Errata Sheet for

Advisory Circular 150/5340-30D, Design Installation Details for Airport Visual Aids

Last Update: March 6, 2009

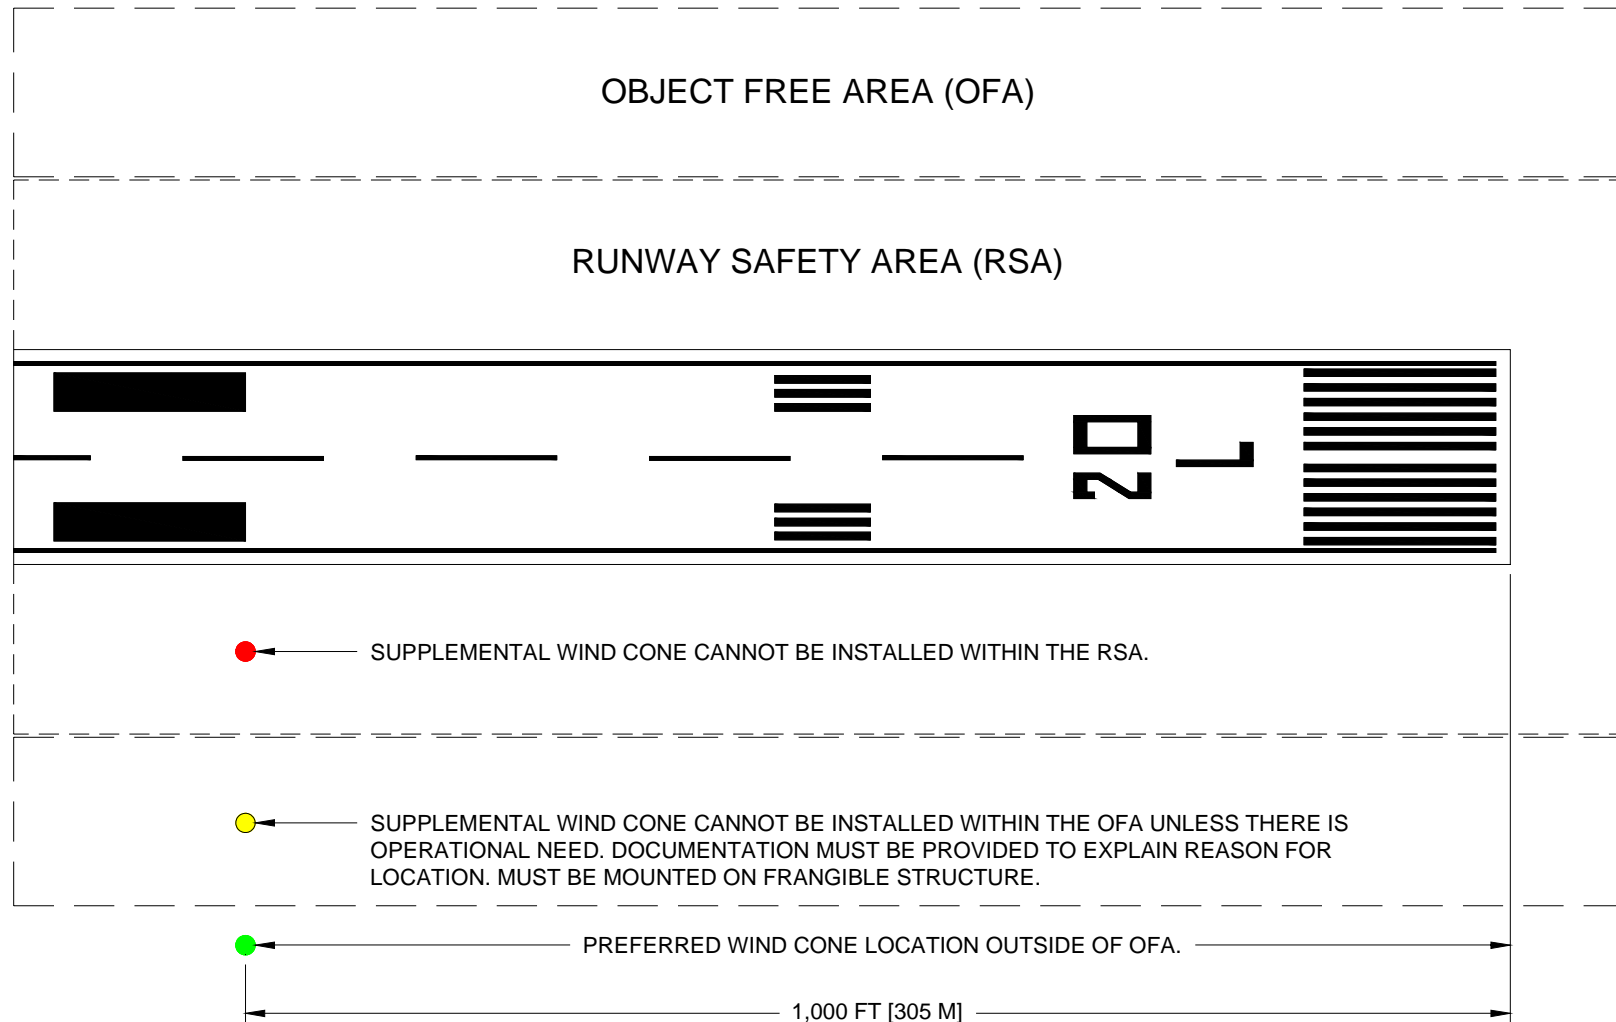
#	Description of Correction	Location	Rationale	Date Error Corrected
1	Add the following after the 3 rd sentence in paragraph 6.3.c: "See Figures 131 and 132 for installation details."	Page 45 (Replace pp. 45-47)	Needed clarification to ensure readers understood standards are applied to primary wind cone.	03/06/09
2	Add the following at the end of paragraph 6.3.c: "See Figures 74 and 75 for installation details on supplemental wind cones."	Page 45 (Replace pp. 45-47)	Needed clarification to ensure readers understood the standards are applied to supplemental wind cone.	03/06/09
3	Replace Figure 74, "Typical Location of Supplemental Wind Cone", with the revised figure (included below).	Page 186	Figure 74 corrected so it is consistent with the standards addressed in section 6.3.	03/06/09

1. THE PREFERRED LOCATION FOR THE SUPPLEMENTAL WIND CONE LOCATION IS BETWEEN 0 AND 1,000 FT FROM THE RUNWAY END.
2. SEE AC 150/5300-13 FOR DETAILED INFORMATION ABOUT THE LENGTH AND WIDTH OF THE RSA AND OFA - DIMENSIONS OF BOTH AREAS ARE DEPENDENT UPON THE AIRPLANE DESIGN GROUP AND AIRCRAFT APPROACH CATEGORY.
3. THE OBSTACLE FREE ZONE (OFZ) IS NOT SHOWN. SEE AC 150/5300-13 FOR DETAILED INFORMATION. THE SUPPLEMENTAL WIND CONE MUST NOT PENETRATE THE OFZ.
